Subject **Response to Traffic Peer Review – Proposed Residential Development – 41
Richmondville Avenue, Westport, Connecticut**

This letter responds to traffic-related comments prepared by CDM Smith, the Town's Traffic Peer Reviewer, for the proposed repurposing of the commercial building to a residential development located on Richmondville Avenue. To assist in your review, we provide the comment (summarized) and our response.

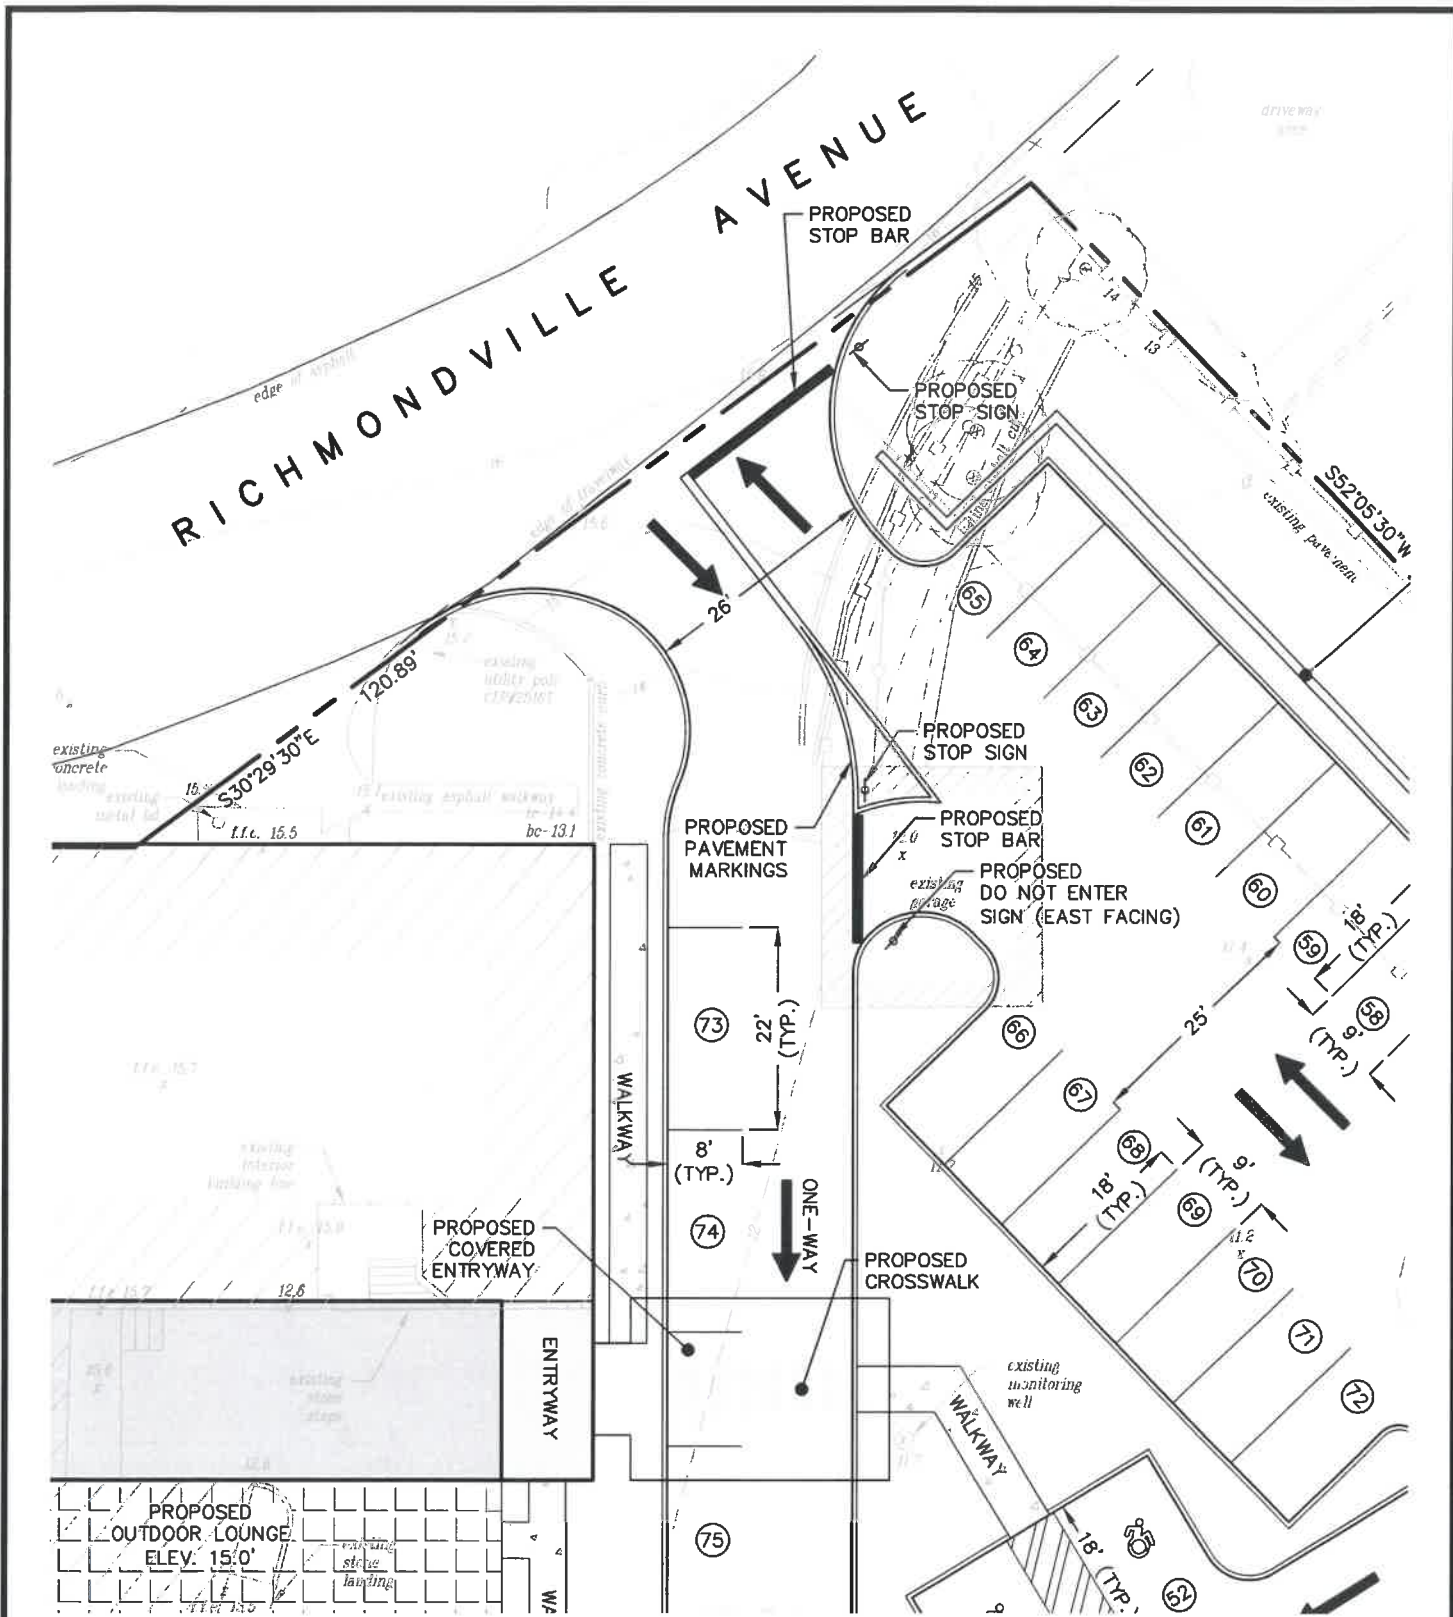
Comment – It appears that there was no Speed Study conducted on Richmondville Avenue. The Applicant should confirm this. In the sightline plan prepared by the Applicant's Civil Engineer, the calculation for intersection sight distance (ISD) is provided based on a 25 mile per hour speed limit. However, the value shown as required is 205 feet. Based on the Connecticut Department of Transportation (CTDOT) Highway Design Manual, the required ISD for passenger vehicles exiting a minor street into a two-lane major street is 280 feet. The Applicant should verify the requirement.

The ISD was based on a 10-foot distance back from the edge of travel way. The CTDOT requirement is 15 feet back from the edge of travel way. The Applicant should depict the sightline based on this requirement.

The sightline plan shows the horizontal distance for sightline requirement but does not consider the vertical relative to the driver's eye and the object position.

Response – The Update Sited Plan prepared by Kousidis Engineering, LLC, indicates the availability of 280 feet for ISD, at a point set back 15 feet from the edge of the travel way at both driveways. However, at the existing north site driveway, to the south it is 265 feet. This is based on the posted speed limit of 25 miles per hour in the vicinity of the site along Richmondville Avenue, which would require 280 feet.

It is important to note that at the existing north access drive a portion of the building will be removed and this will have a significant benefit and improvement to visibility to the south of the northerly driveway.

A reduced copy of the Site Plan is attached for reference only. The full package will include a full size Site Plan package.

INTERSECTION SIGHT DISTANCE (ISD):
 ISD = $1.47 \times V_{major} \times t_g$
 $V_{major} = 25 \text{ mph}$
 $t_g = 7.5 \text{ seconds}$
 ISD = $1.47 \times 25 \times 7.5$
 REQUIRED ISD = 276 FT REQUIRED
 PROVIDED ISD = 280 FT > 276 FT

SOUTH ENTRANCE SCHEMATIC

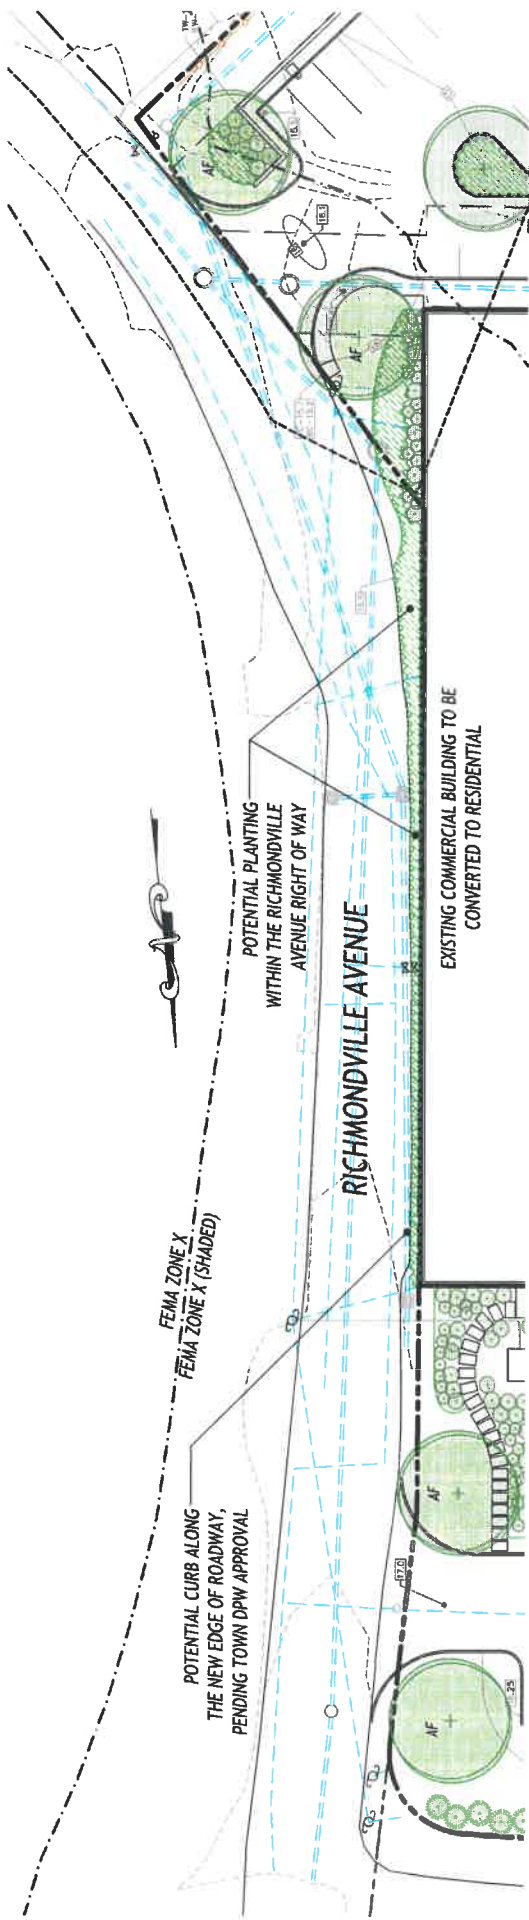
Comment – The existing southerly driveway is one-way (ENTRANCE ONLY). The Applicant should clarify the reason for converting the southerly driveway into a two-way driveway. As indicated earlier, there are sight line concerns for motorists exiting this driveway. In addition, the Richmondville Avenue/southerly site driveway intersection is not perfectly aligned. During the field

visit, it was noted that motorists turning left from Richmondville Avenue into the driveway are closer to the southerly edge. This creates a concern with the driveway being converted to two-way operation with exiting traffic.

Response – As noted above, the purpose for converting the southerly site driveway to a two-way traffic flow was to provide direct access to the main entrance to the building and deliveries and to permit that delivery truck to immediately exit the site to turn to Richmondville Avenue. Further, it was converted to provide access to the lower parking area and to provide a direct exit from this parking area to Richmondville Avenue. The concern was to minimize the level of site traffic traveling behind the building and near the residence located on Mill Bank Road which is located to the rear of the site.

As part of the improvements to the site the existing southerly driveway will be improved and modified to provide an appropriate alignment of the site driveway to Richmondville Avenue. It is important to note that as part of the modifications to this existing driveway the amount of pavement area will be reduced so that it approaches Richmondville Avenue at an approximately 90 degree angle and with appropriate radii to control turning movements in and out of the Subject Property. In reference to current motorists entering the southerly driveway and driving on the wrong side of the driveway entrance, it is important to note that this driveway is currently one-way and this motorist is not on the wrong side of the road. However, in the future, this driveway will be two-way, with appropriate radii and a reduced pavement area, a STOP bar and STOP sign and a double yellow centerline to clearly designate it a two-way, two-lane driveway. We are confident that these improvements will mitigate the motorist traveling on the wrong side of the driveway if it was to be a two-way driveway configuration in the future.

In reference to the two-way traffic flow in and out of the Subject Property from Richmondville Avenue into the lower parking area, it is our opinion that there is not an alignment issue in a traffic control and traffic flow issue. This is typically found in parking areas and parking spaces located near entrance drives. However, to respond to this concern, the updated Site Plan provides a configuration, which clearly denotes the STOP bar and double yellow centerline, a painted center

median and better traffic control and traffic flow to clearly designate a U-turn area and to separate it as much as possible from the motorist entering the site from Richmondville Avenue.
